### **REPORT ON THE ASSESSMENT OF A MODIFICATION PURSUANT TO SECTION 96(2) OF THE ENVIRONMENTAL PLANNING AND ASSESSMENT ACT 1979**

**APPLICATION (DA-250-10-2004 MOD 1) BY WOODLAWN WIND PTY LTD TO MODIFY DEVELOPMENT CONSENT GRANTED ON 4 OCTOBER 2005 FOR THE WOODLAWN WIND FARM PROJECT**

April 2010

**Figure 3: Proposed Amended Woodlawn Wind Farm Layout (reproduced from the Applicant's Statement of Environmental Effects)**

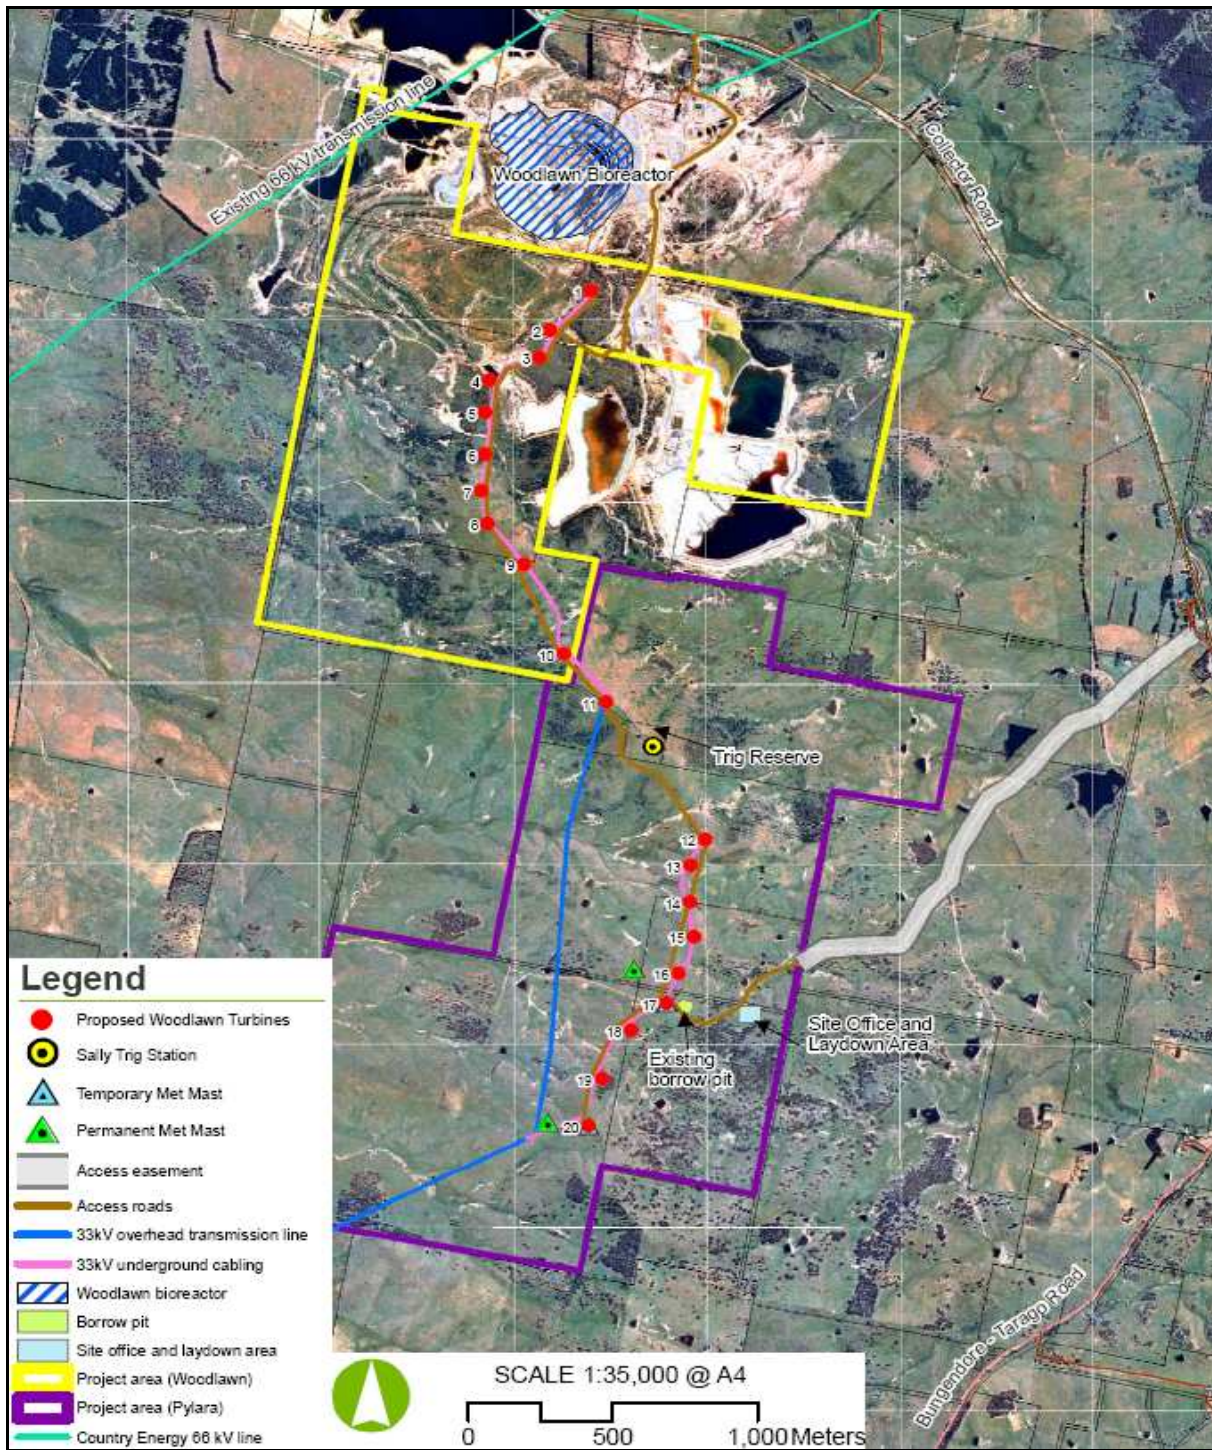
With the reduction in the overall number of turbines from 25 to 20, the number of turbines located on some of the properties will be varied from the original application, however all turbines will still be located within the original turbine array envelope. Most of the land parcels on which the turbines have been proposed, will now be subject to different number of turbines (from the original layout), with the highest change being a reduction of two turbines.

The maximum distance of an amended turbine site from a previously approved turbine site is 245 metres in the case of Turbine 10, which is located in an area where no turbine sites had previously been positioned. Also, none of the revised turbine sites are located in the area of the former Turbine sites 13, 14 and 15.

**Figure 7:** Overview of culturally significant sites (reproduced from the Applicant's Statement of Environmental Effects)

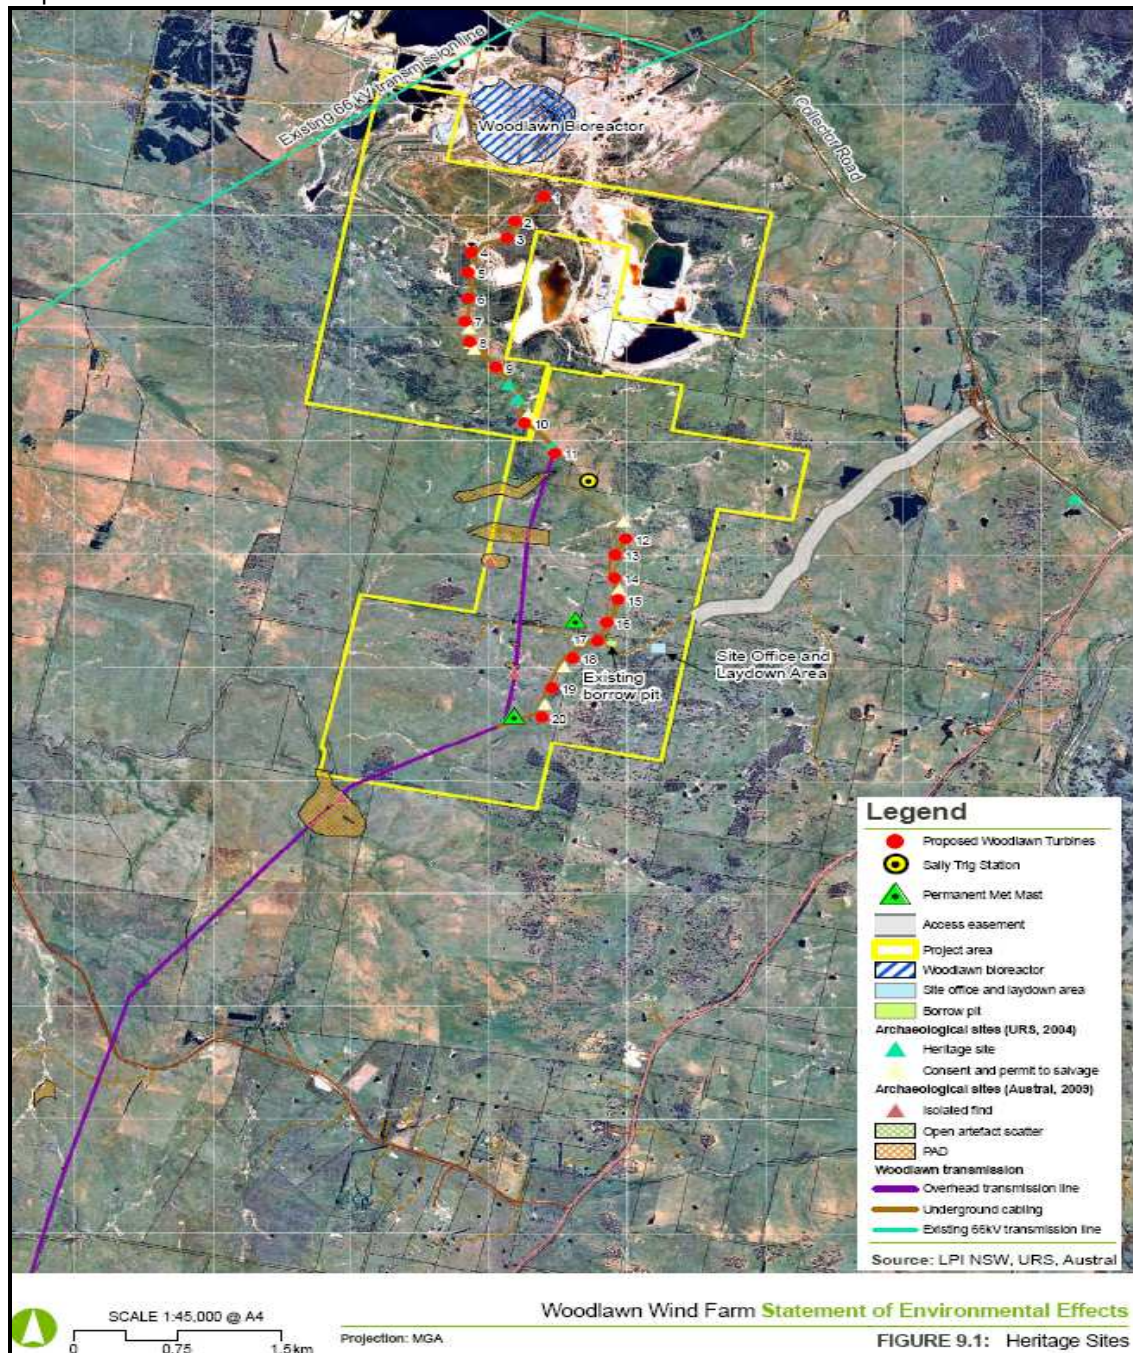
Three survey units were covered in the field assessment, comprising northern, central and southern sections of the proposed transmission line route. Two isolated finds and three open artefact scatters were visible in the study area. Seven areas of archaeological potential were identified in the study area, two of which were in association with the surface material, while the remainder were determined based on landform characteristics alone. One particular site (WLTL-C SITE 3) was estimated as having 80 to 100 artefacts scattered across the surface, such as ground edge axes and nodules. It was found that most of the individual sites assessed in the study area had a low potential for new information, except for WLTL-C SITE 3 (moderate) and WLTL-C PAD 3 (high). The rarity of the findings at each individual site were assessed as low in most of the sites, except for WLTL-C SITE 2 (moderate), WLTL-C SITE 3

(moderate to high) and WLTL-C PAD 3 (moderate). These three sites also contained a moderate to high research potential. The recommendations made by the Applicant's consultants are to avoid impact to all these sites, and in addition apply for a section 87 Preliminary Research Permit for WLTL-C PAD 3, to characterise archaeological resources if avoidance is not possible for this site. Refer to Figure 7 of this Report.

The Department is satisfied that the impacts to indigenous heritage from the modified project can be mitigated and/or managed in consultation with the appropriate Aboriginal stakeholders and the adherence to requirements of existing permits for the development with regards to indigenous heritage. The Department has recommended amendments to the existing consent to address the modified wind turbine layout and the transmission line route.
